Proposed Parking Facility 1165 Barrenjoey Road, Palm Beach

Stage 3 Design Road Safety Audit Report

September 2019

Report No: PT19058r01_V1

Drawing No.
DA01

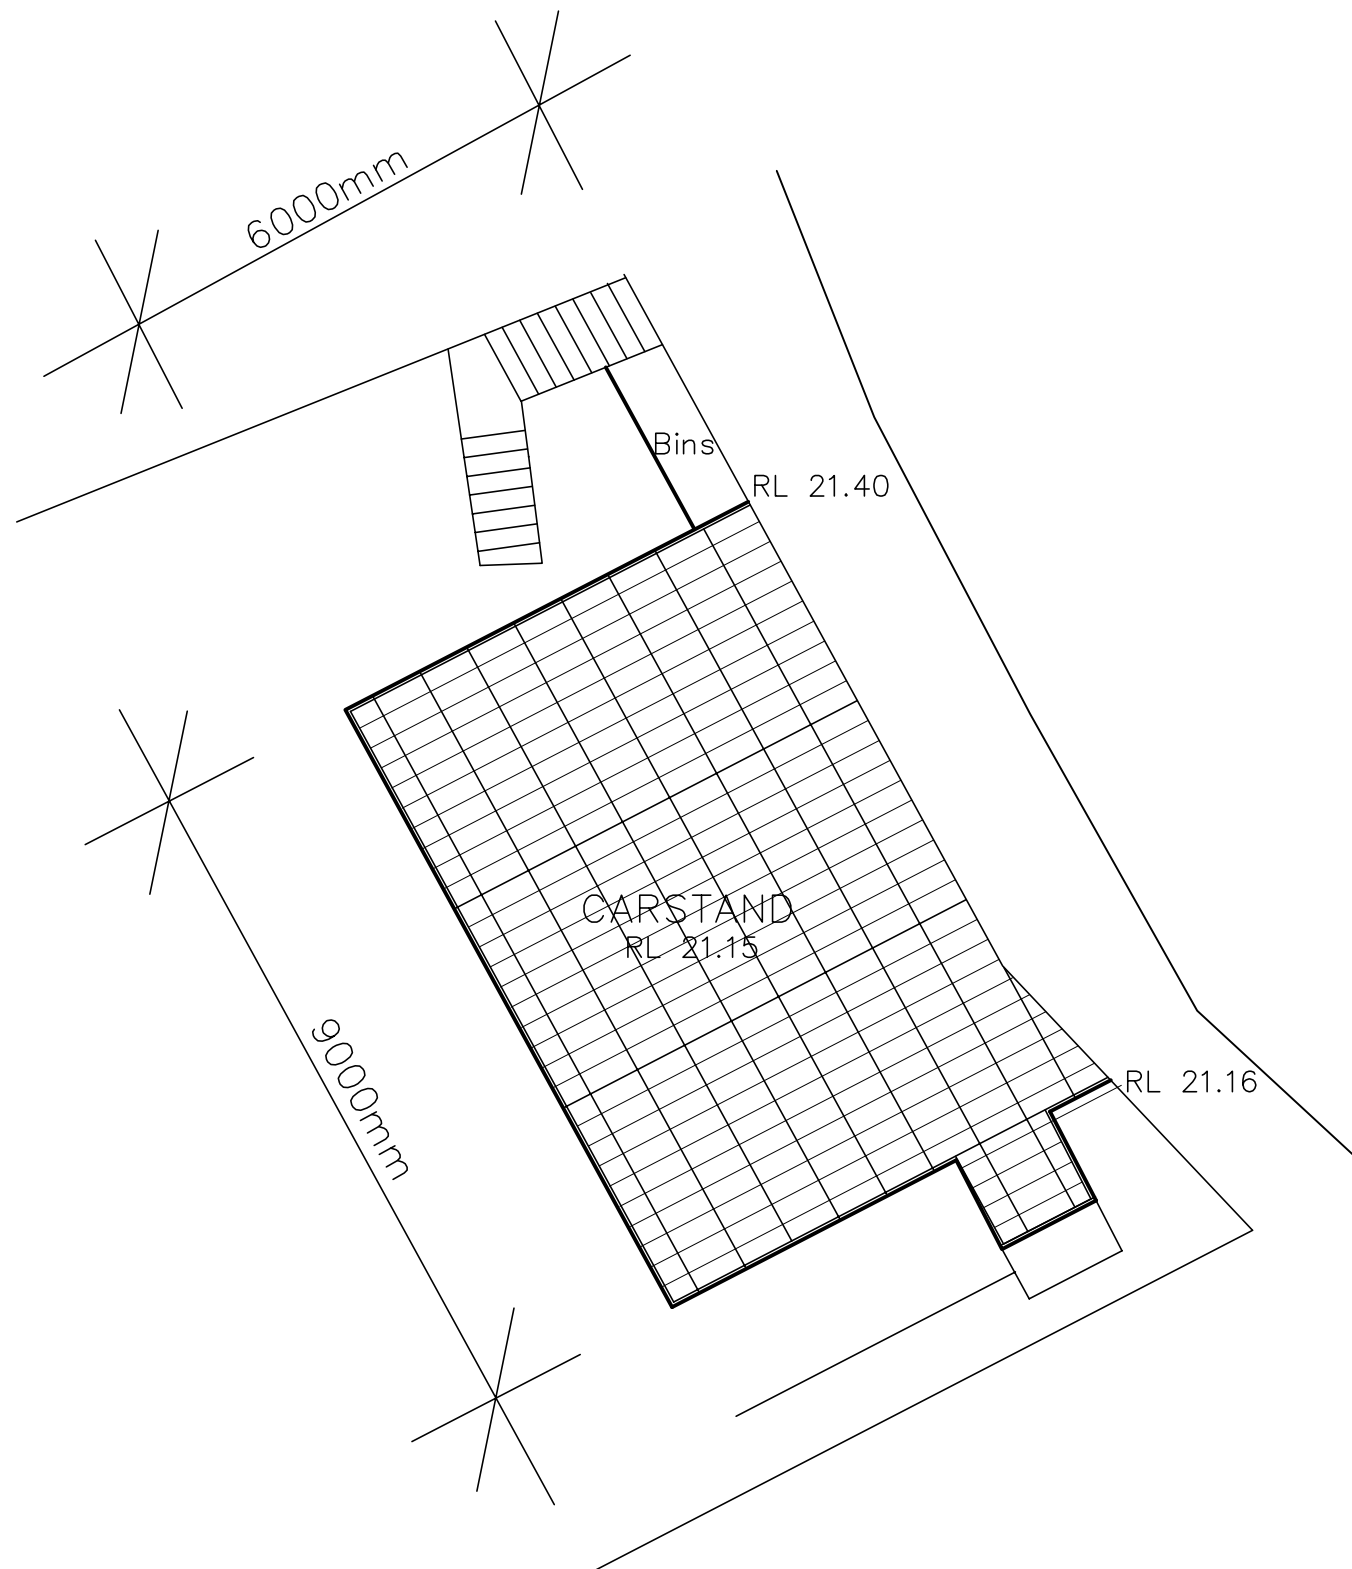
No.	Item	Description	Risk	Audit Team Assessment/Comment	Client Representative Comment
1.	Shortened Barrier	Reduction of barrier requires appropriate end treatment	High	Condition of consent	
2.	Sight Lines	Sight lines to southbound traffic around bend	Low	Provision of convex mirror on southern side of parking deck would assist	
3.	Removal of barrier	Removal of existing barrier and replacement with new barrier around parking deck	Low	Marginal increase to pedestrian / vehicle collision risk	
4.	Curve Speed	The existing bend north of the subject site does not include curve speed advisory signage	Med	Approaching traffic to the bend in either direction would benefit from curve speed advisory signage
